This Service Information bulletin supersedes SI B12 14 12 **dated August 2013.**

**N51, N52K, N52T and N55 Engine: Various Faults Stored in DME Related to VANOS and Camshaft Position**

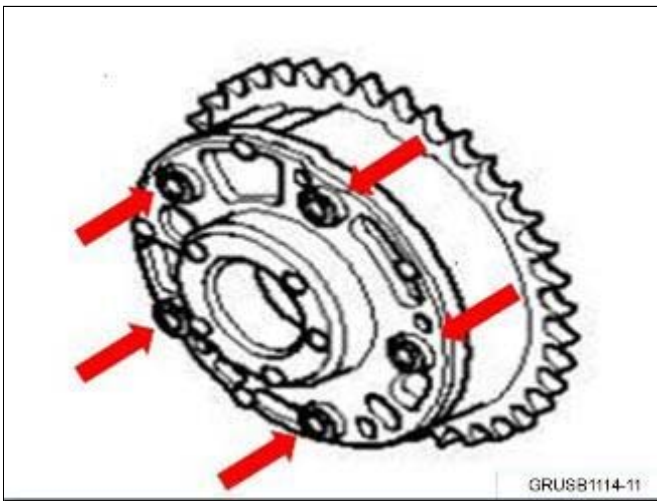
One or both (intake and/or exhaust) of the VANOS gear assemblies have faulty assembly bolts. One or more of the five assembly bolts have loosened or broken. The location of these bolts is shown in the illustration below:

1. Replace **both** VANOS gear assemblies. Refer to Repair Instruction 11 36 046, “Removing and installing or replacing intake and exhaust camshaft units.”
2. If the bolts have been found broken, the missing portions of the bolts will need to be retrieved from the engine before the final repairs are made. This additional work may include removing the engine oil pan, and a close examination of the timing chain drive to retrieve the missing parts. Refer to the applicable repair instructions for oil pan removal procedures.
